FINAL INITIAL STUDY AND
MITIGATED NEGATIVE DECLARATION

Project Name: J. Craig Venter Institute
UCSD Project Number: 968434
University of California, San Diego

June 28, 2007

**NOTE TO REVIEWERS OF THE FINAL TIERED INITIAL STUDY
 AND MITIGATED NEGATIVE DECLARATION**

EXHIBIT 1

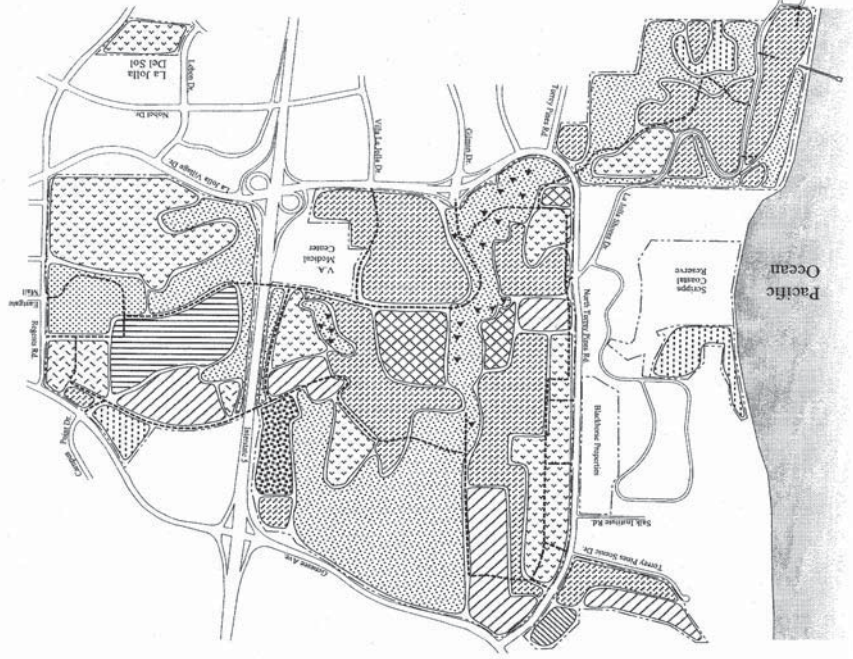
Page 52: Land Use and Planning b) The project does conflict with the LRD P and the La Jolla Community Plan. The Land Use identified for this site is Academic [Exhibit 1]. The proposed use is Academic/Science Research Park [Exhibit 2]. This is a "potentially significant

F20 As discussed under response F1, the proposed project would be consistent with the 2004 LRD P land use designation and is an appropriate use for the area in consideration of the intended development goals of the SIO Upper Mesa. Refer to response F1, above, for further discussion of this issue.

Proposed UCSD Utility Connections

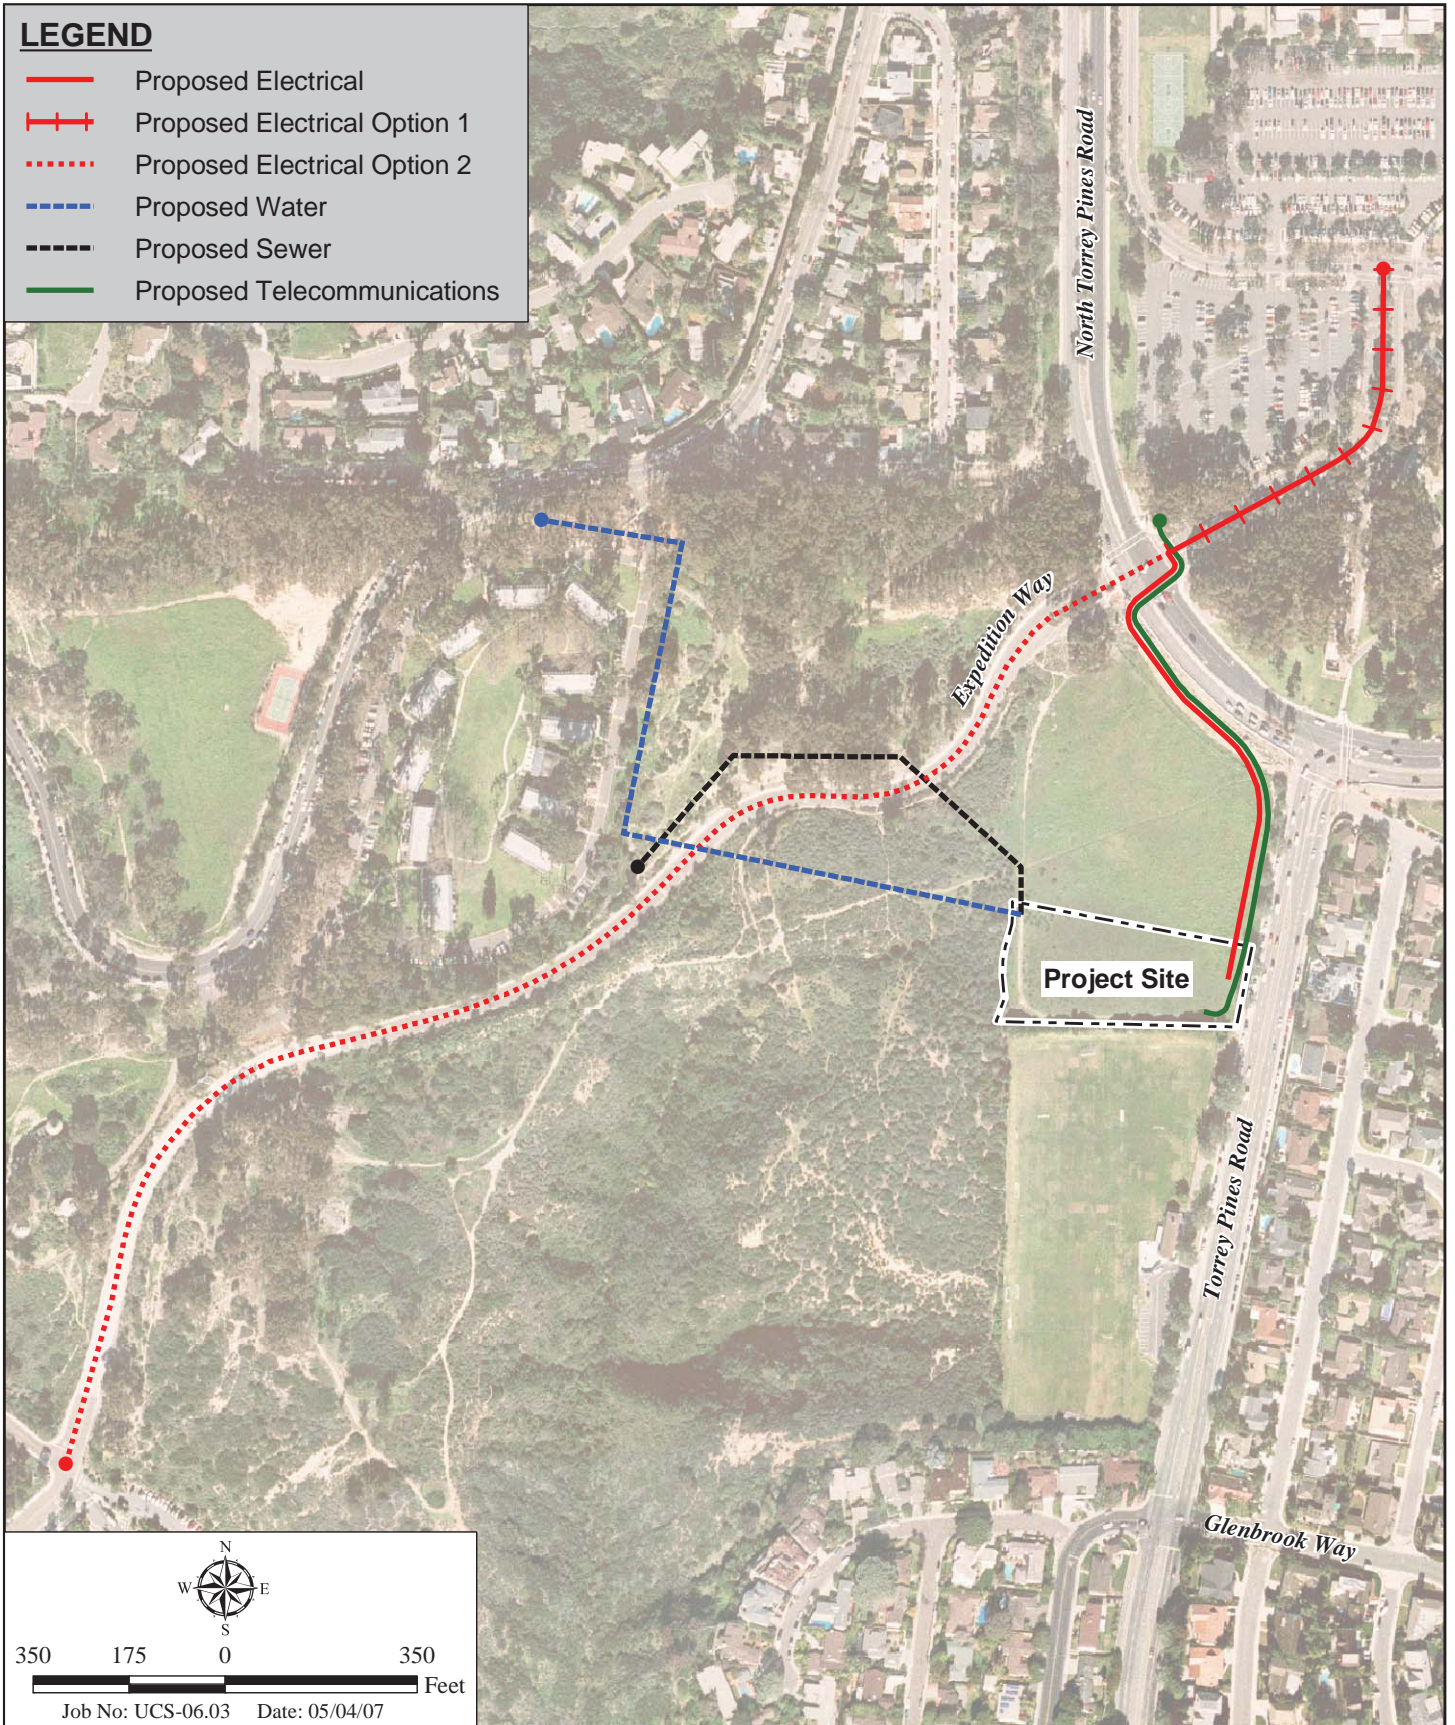
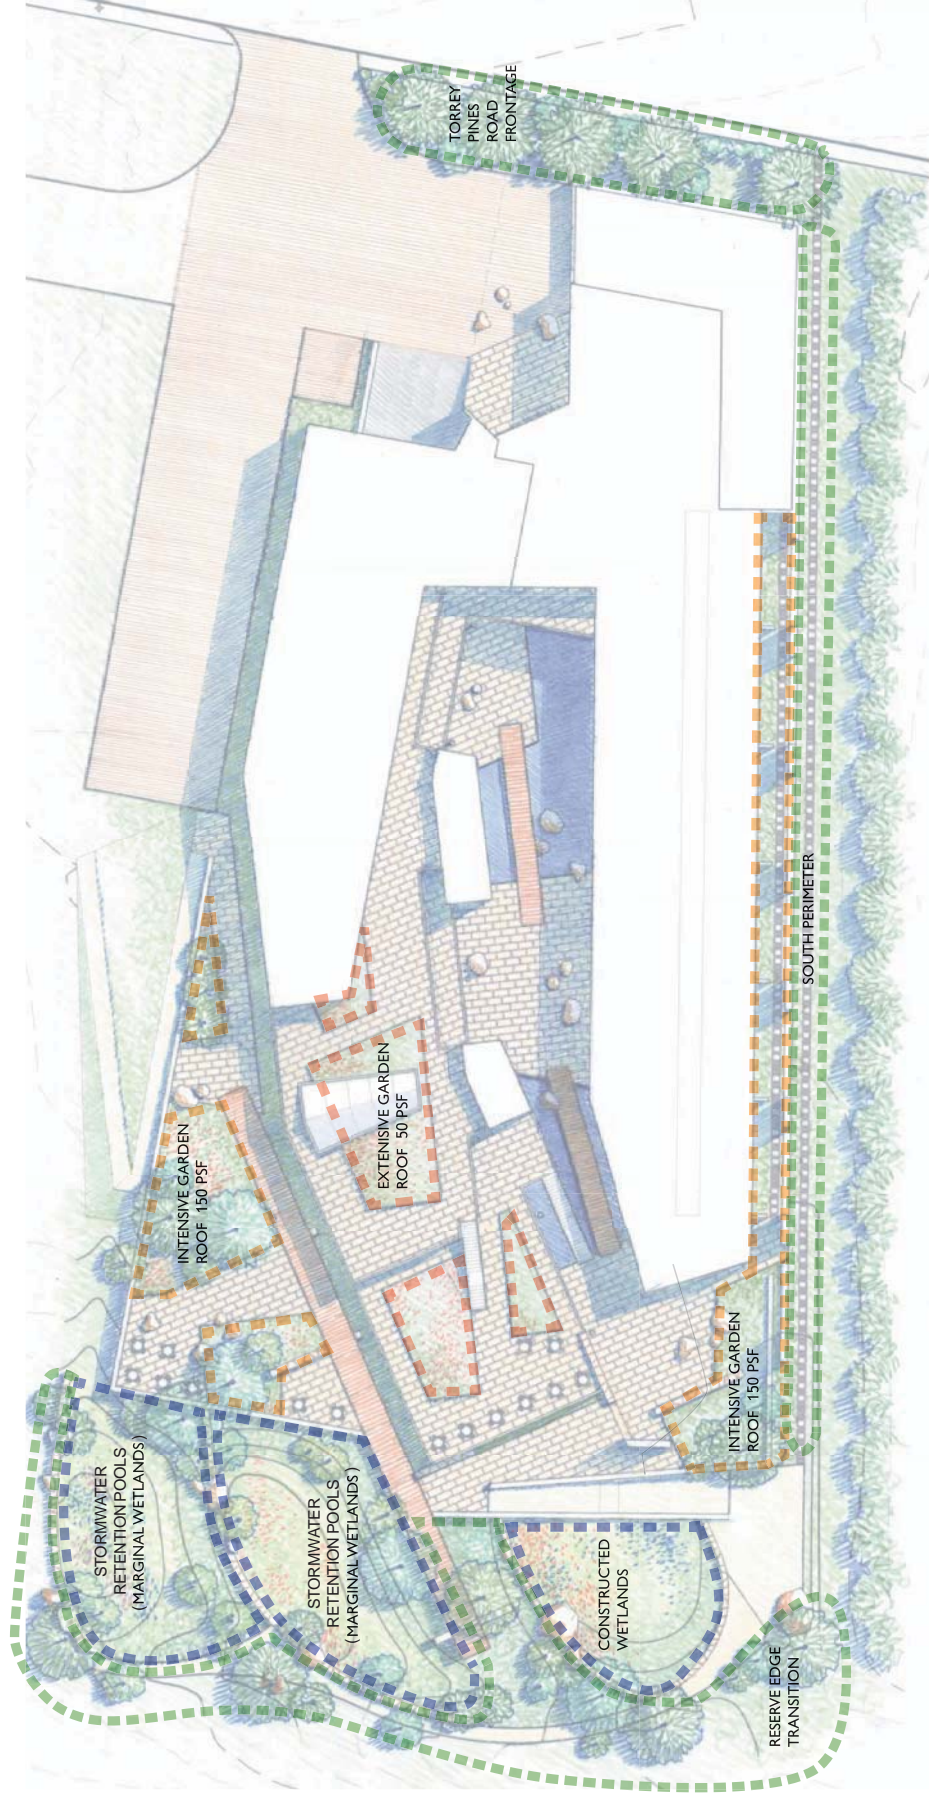
Moreover, Figure 7, Proposed UCSD Utility Connections, shows proposed sewer and water lines running through the Ecological Reserve and into the Coast Apartments area. We respectfully request that alternatives be pursued that would run the lines through already impacted areas and NOT run utility lines through the Ecological Reserve and that those running through the Reserve be rejected to better protect any tribal cultural resources that may be present.
